# COUNTY OF SANTA CRUZ

**SUBJECT: APPEAL OF ZONING ADMINISTRATOR APPROVAL OF APPLICATION 08-0237**

On June 5, 2008 the Zoning Administrator approved Time Extension and Amendment to 05-0305 (Coastal Development Permit, Residential Development Permit for a fence of 6 feet in height within the required front yard setback, Large Dwelling Review, and a Grading Permit), to make minor exterior modifications to the previous approval, a second floor addition of around 900 square feet over the garage, and add approximately 1,000 square feet of deck to the second floor. On June 16, 2009 the Planning Department accepted the applicant's appeal of the Zoning Administrator's approval (Letter of Appeal, Attachment 1). Per Section 18.10.330 of the County Code, a public hearing has been set before your Planning Commission to consider the appeal.

2nd. FLOOR PLAN A-3

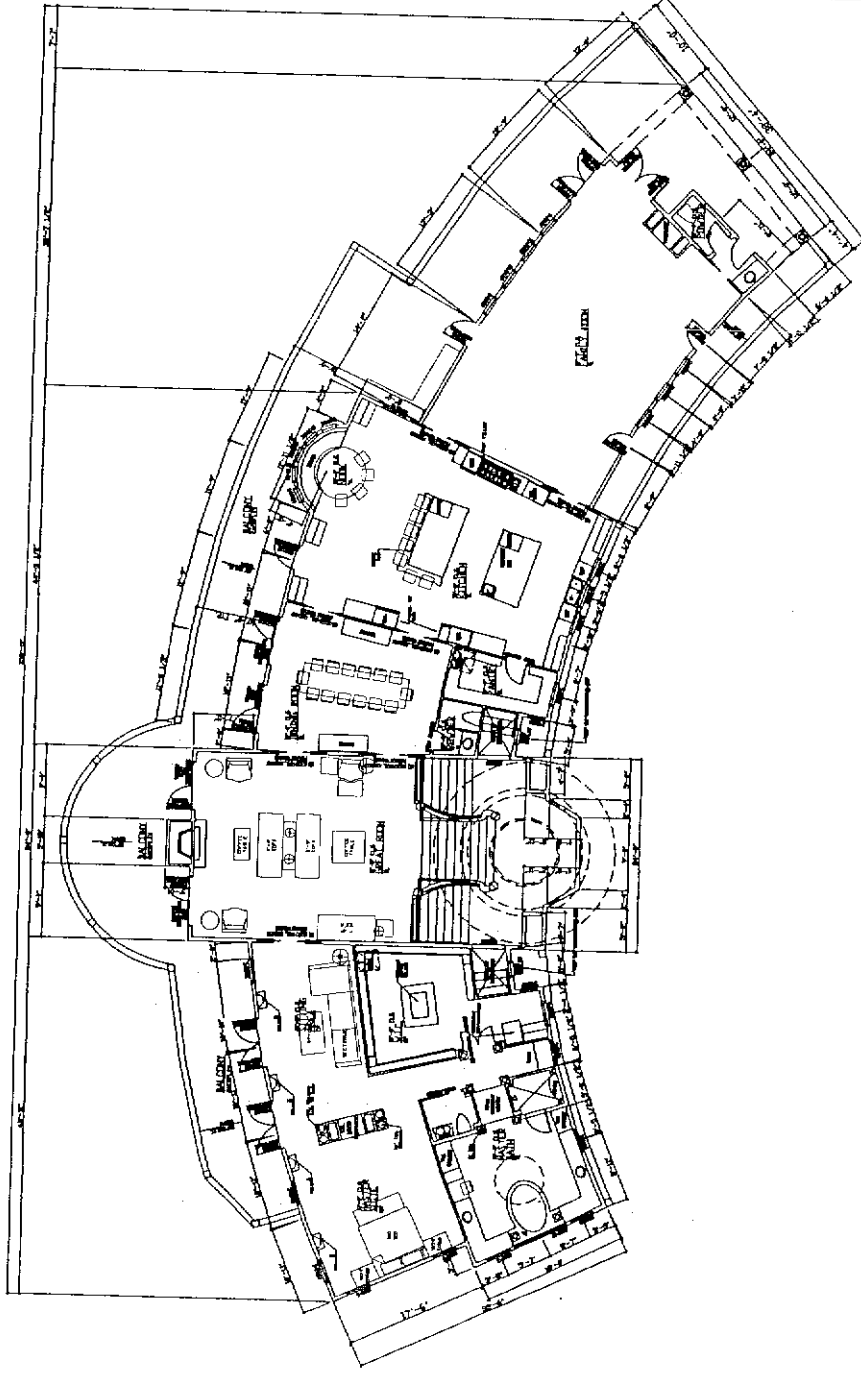
Of particular concern is the proposed second floor addition of approximately 900 sq ft above the 1,234 sq ft garage which extends into the slope. Our property and the applicant's are situated on the same San Andreas Ridge with a slope that spans the rear portion of most of the homes on that side of the street. We are questioning the stability of the slope as a result of such huge construction especially with a large displacement of dirt in close proximity to us, and the foreseeable consequences of a major slide. I use the word "major" because we currently have problems with erosion and soil movement after heavy rains, from rain water running off into the creek below. Although our house is built on the flat part of our property and nowhere near the slope, we nevertheless have 3 levels of retaining walls in place due to erosion problems. But that wasn't enough. Just this month, we laid down erosion control wires and mulch over the slope to prevent downhill run-off water from further eroding the soil, and hopefully avert the possibility of a land slide.

Furthermore, the addition above the garage is one our main concerns, because it adversely impacts our property. The second floor addition of a family room with a covered patio above the garage directly faces into our property in an area where there are no trees or landscaping to provide privacy.

Furthermore, the second story addition is broken up by recessing the wall plane and including a open covered patio area. A condition of approval has been added to the permit that requires the color of the home be revised to a darker earth tone color to minimize any impact to the San Andreas Road scenic corridor.

# Shadow Plan

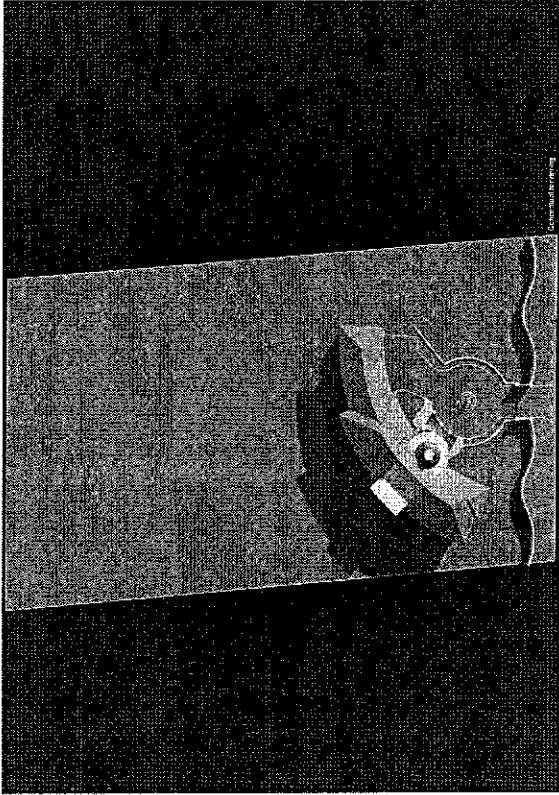
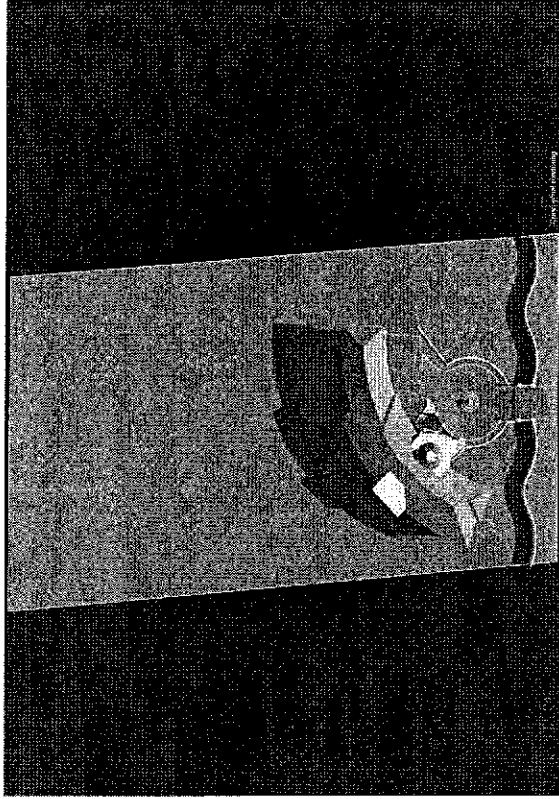
The final appeal issue is that the appellant's solar panels will be shaded. As previously stated, the proposed home is located over 45 feet away from the neighboring property line to the east and the solar panels in question are located in the northeast corner of the neighboring property. A shadow plan demonstrates that the proposed home will not shade the solar panels (Exhibit 2G). The solar panels are distant from the home and the existing trees which are closer to the solar panels are much taller than the proposed home.

What's more, this project will affect our 36 panel solar energy system by shading off the sun sooner in the late afternoons. We feel that the Planning Staff did not employ due diligence in compiling their report for this project.
